Re: Zoning Change, Site Plan and Special Permit Application Review

404 Berlin Turnpike

We are in receipt of your review comments dated February 1, 2021, regarding the project noted above. Our responses are indicated below in *bold italic* text and are as follows:

SP-0

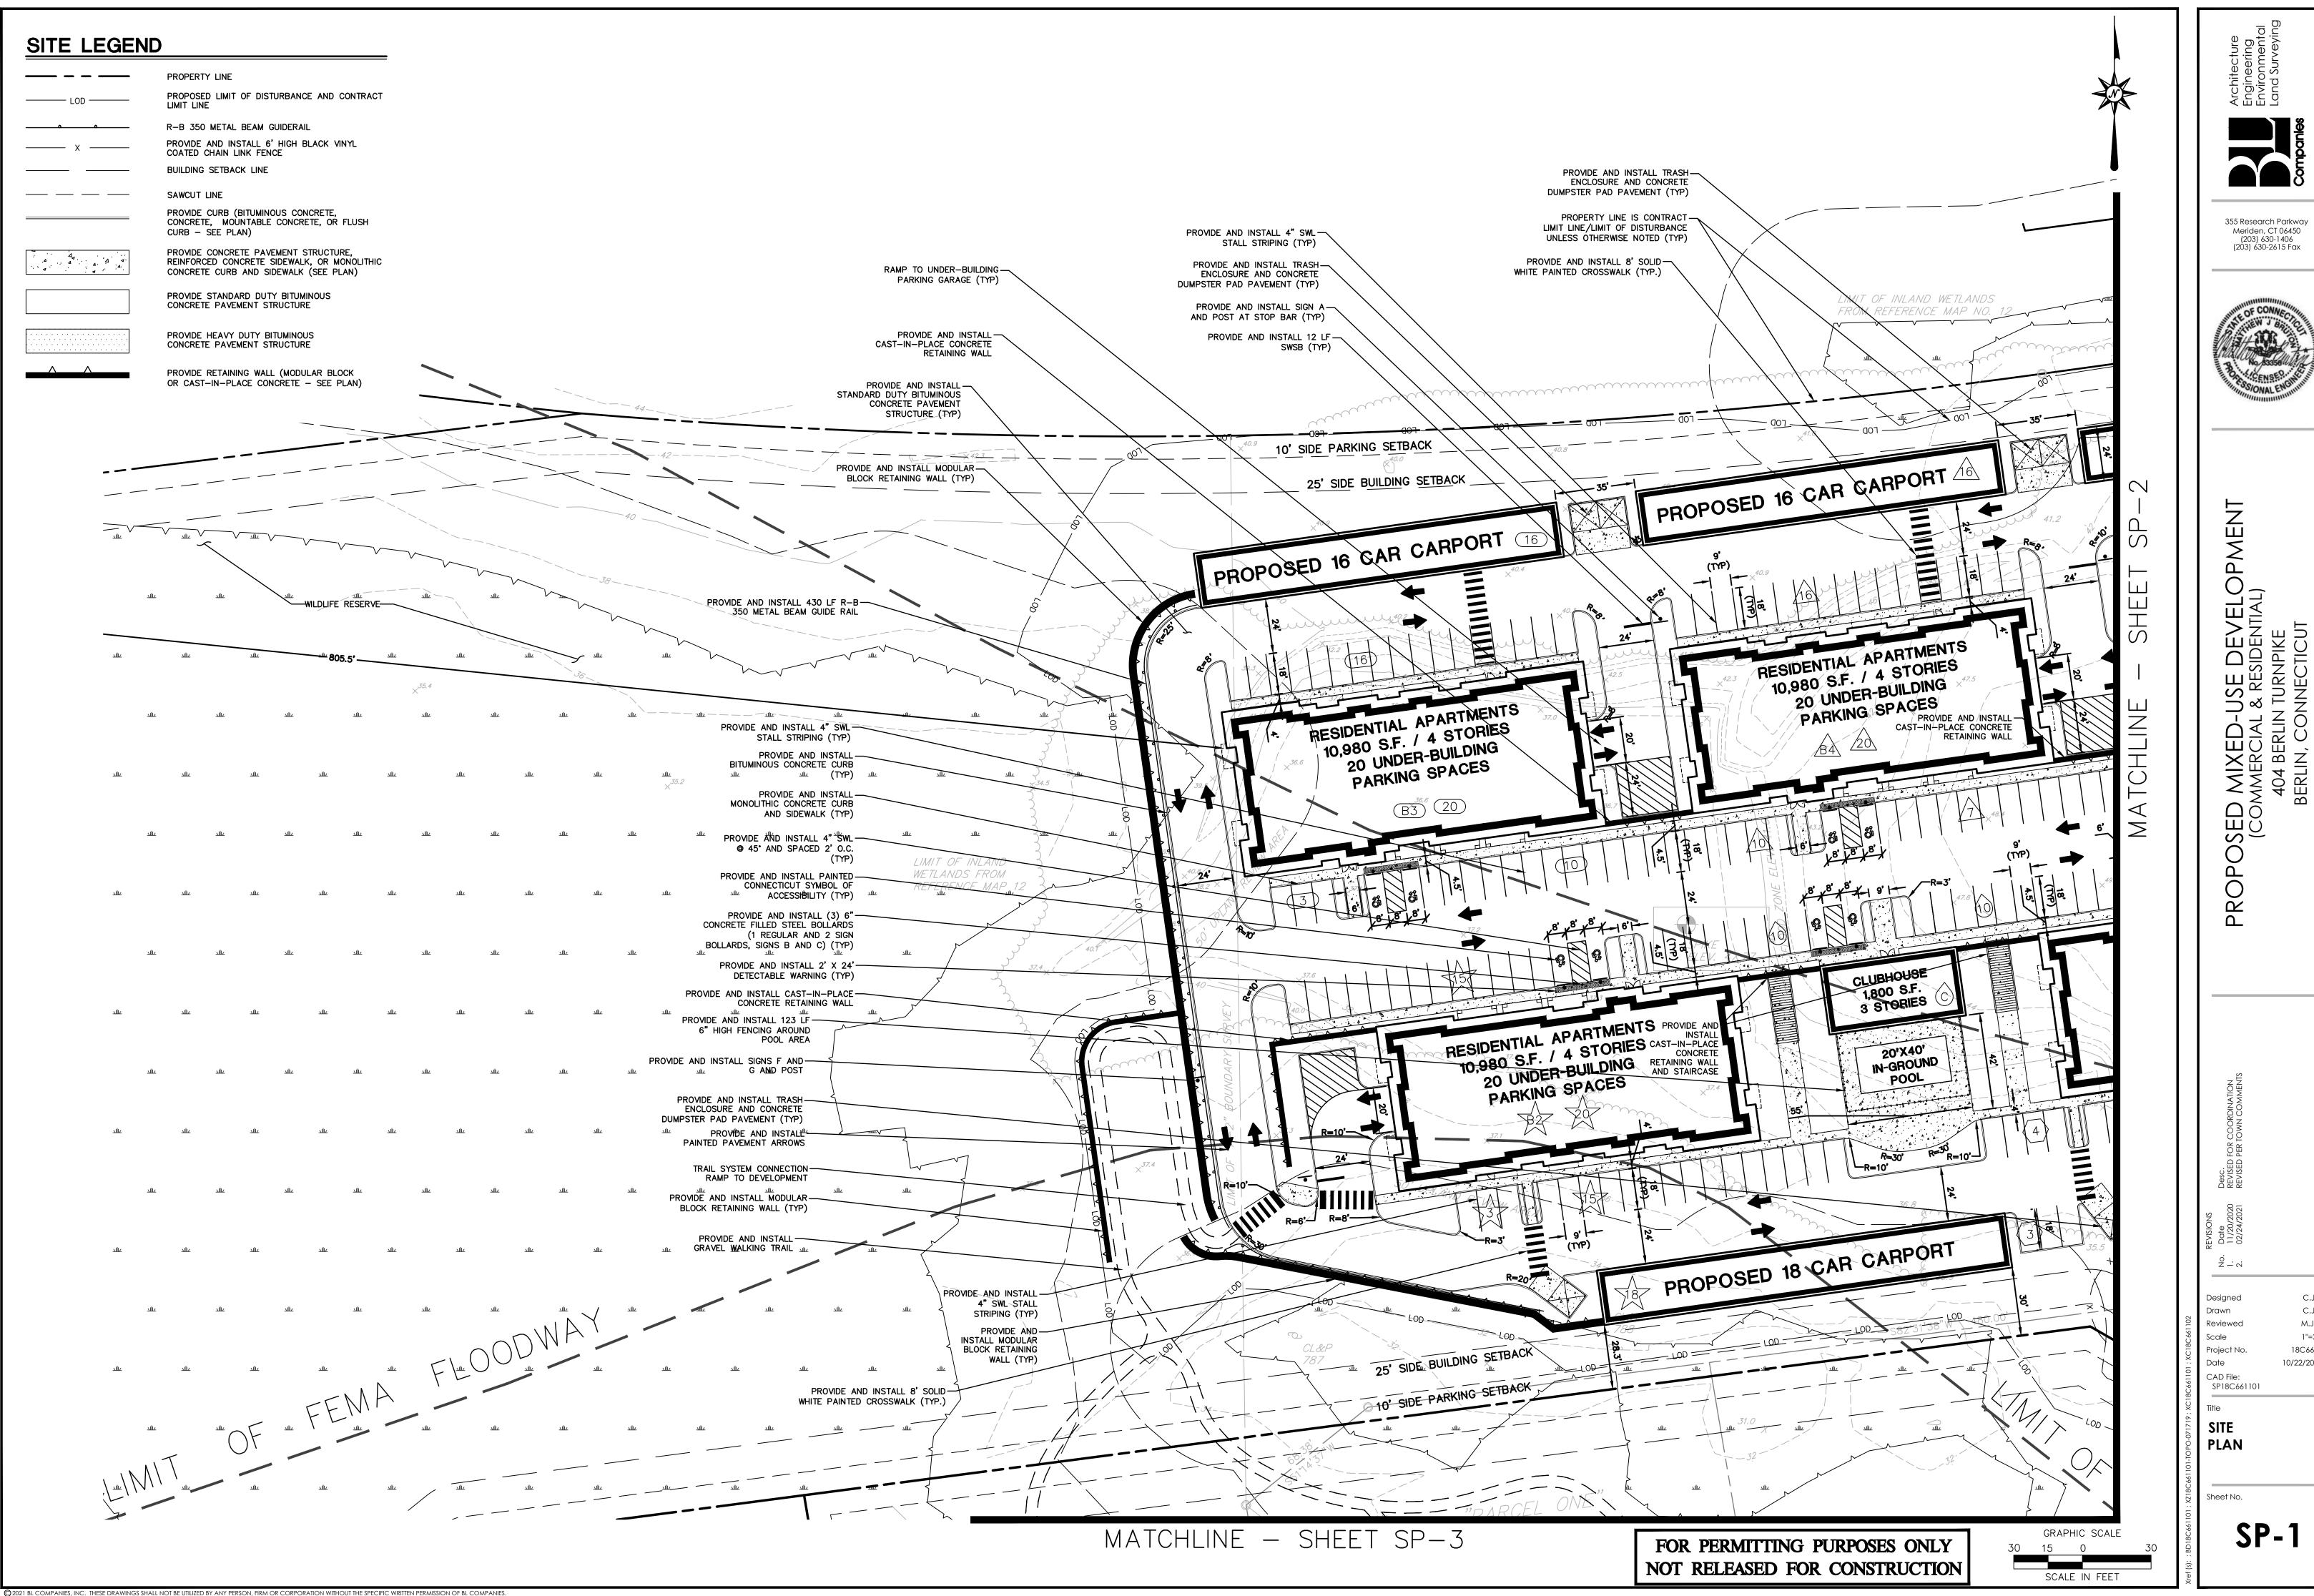
4. Regarding vehicle circulation and pedestrian safety, the lack of parking near the store front (other than the two accessible spaces) creates a circumstance where customers will need to walk across vehicle travel lanes or through the filling station area to access the store. Therefore, the Commission may want to consider having the applicant provide pedestrian crosswalks from the parking areas to the storefront. In addition, the seven parking spaces south of the storefront may better serve the store than the spaces along the frontage. Therefore, the seven spaces south of the store may be suitable for designation for the store and spaces along the frontage could be designated for use by the conservation area.

5. Regarding vehicle circulation and pedestrian safety, the Commission may want to consider having the applicant provide pedestrian crosswalks from the two southern residential buildings across the parking area and travel lane to the trash receptacles. This may require the removal of a few parking spaces (see discussion of parking requirements in Section IV).

6. The site plan and parking area designs do not appear to provide for loading areas to accommodate tenants moving in and out. Without such designated areas, it is likely that moving related vehicles may double park, potentially blocking access to parking spaces and constraining the travel-way. Therefore, the Commission may want to consider having the applicant provide loading areas for each of the five buildings. Providing loading areas may require the removal of some parking spaces (see discussion of parking requirements in Section IV).

10. Hotel guests utilizing the shared parking at the retail site to the south will need to walk across the travel area of the main entrance and exit to the site. This area will likely experience the highest vehicle traffic volumes on the site. Therefore, the Commission may want to have the applicant provide pedestrian crosswalks between the hotel and the retail site parking area. Providing crosswalks may require the removal of some parking spaces (see discussion of parking requirements in Section IV).

the store to make a purchase. In response to your comment, pedestrian crosswalks have been added to the plan connecting the frontage parking spaces as well as the 7 spaces south of the building. The spaces south of the building are designated for shared use by both the convenience store and the conservation area.

Response: Pedestrian crosswalks have been added to the Site Plan connecting the two southern residential buildings to the dumpster locations.

Response: Acknowledged, dedicated loading areas have been added to the revised Site Plan. There are two loading areas approximately 24'x24' for both the north and south rows of residential buildings. They are located between buildings D and C and between buildings C and B in the north row, and to the west of building F and east of building E in the south row.

Response: A crosswalk and pedestrian curb ramp system has been added connecting the hotel to the phase 3 retail area. These additions have resulted in a net loss of 2 parking spaces.
